To: Kristopher Byrd, Well Construction and Compliance Section Manager
From: Travis Kelly, Well Construction Program Coordinator
Subject: Review of Water Right Application G-18967
Date: August 18, 2020

Groundwater Application Review Summary Form

Application # G- 18967

TO: Water Rights Section Date 8/12/2020
 FROM: Groundwater Section Travis Brown
 Reviewer's Name
 SUBJECT: Application G- 18967 Supersedes review of _____
 Date of Review(s) _____

Water Well Completion Statistics – T5S/R1E-12

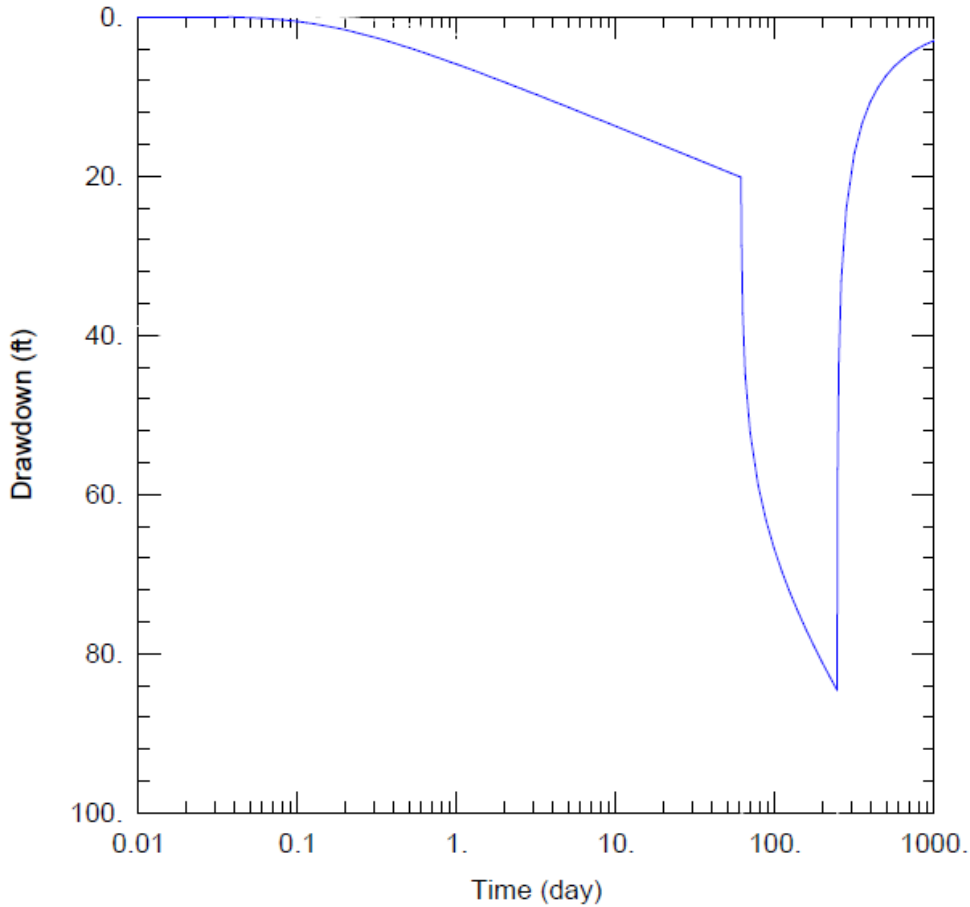
The proposed POA produce water from saturated sand within the Troutdale Formation, with water-bearing zones noted from depths of ~347 to 399 ft bls (elevation ~ -27 to -92 ft msl). Well completion statistics indicate falling head with depth in this area (see attached Well Completion Statistics).

Interference Analysis – Application G-18967 Maximum Rate Requested (1.63 cfs)

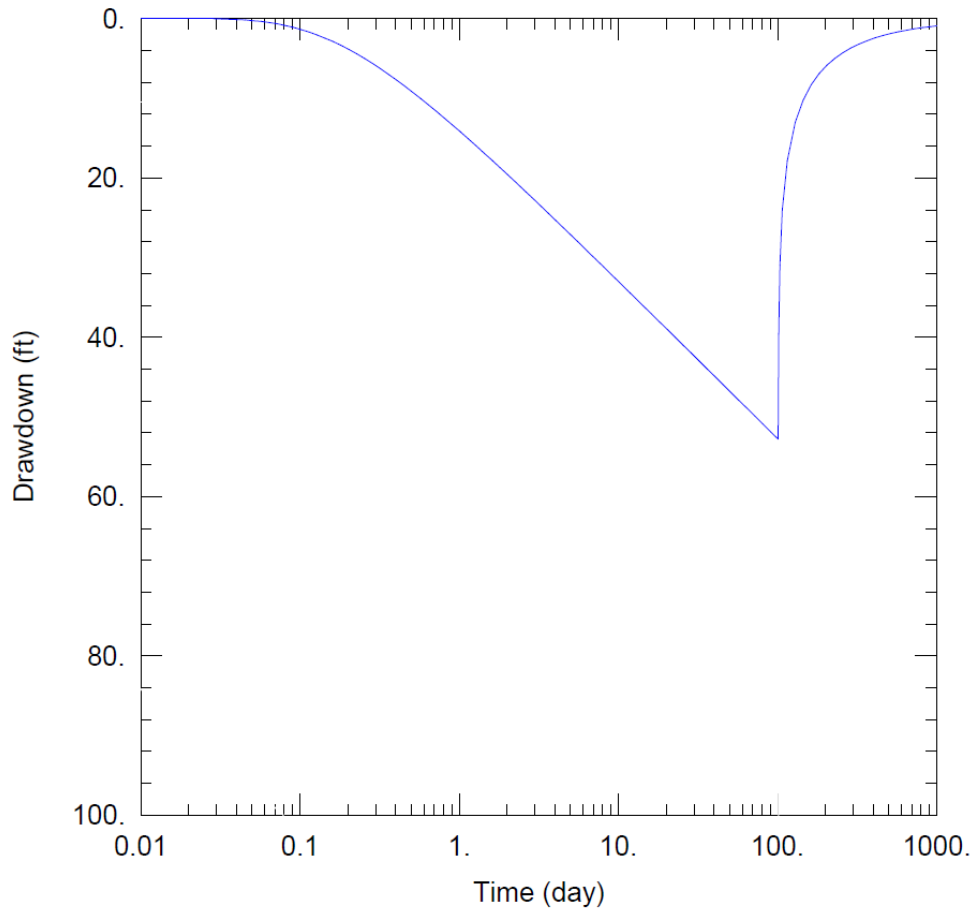
The nearest neighboring well to the proposed POA is CLAC 66134, an authorized POA under **Certificate 92166*** and **Permits G-15254*** and **G-18008***. Interference with CLAC 66134 due to the proposed use was estimated using the Theis (1935) equation for drawdown in a confined aquifer. To provide a reasonable but still conservative analysis, it was assumed that both POA would pump continuously from March 1 through April 30 (61 days) at the necessary minimum rate (~0.67 cfs) to achieve the applicable duty under **Application G-18967** and subsequently at their maximum reported yield (~2.41 cfs) from May 1 through October 30 (183 days), to account for the potential overlapping use under **Permit G-17897***. **Results of the analysis indicate that by the end of the irrigation season (October 30), interference with CLAC 66134 could exceed ~84 ft of drawdown from the combined use of Application G-18967 and Permit G-17897* (see attached Interference Analysis). Standard condition 7n, recommended for any permit issued pursuant to this application, stipulates that use of water from the proposed POA must be curtailed if interference with a neighboring well exceeds 25 ft of drawdown. Analyzing the impact of just the use proposed under Application G-18967 indicated that at the maximum rate of use (1.63 cfs), interference with CLAC 66134 would likely exceed 25 ft of drawdown after ~4 days of continuous pumping. Therefore, the proposed use is not likely to be available in the amounts requested without injury to prior water rights.**

Water levels reported for POA 1 (CLAC 53757) and CLAC 66134 indicate a moderate declining trend, with observed declines averaging ~0.5 ft/yr over the last decade for CLAC 66134 (see attached Hydrographs). Additional use of the proposed POA could exacerbate these declines. If a permit is issued pursuant to this application, the conditions listed in B1(d)(i) and B2(c) are strongly recommended to protect senior users and the groundwater resource. **The reference water level for the proposed POA under Condition 7n should be set at the same level as currently established for POA well CLAC 53757 (126.66 ft bls / 193.34 ft AMSL) under Permit G-17897*.**
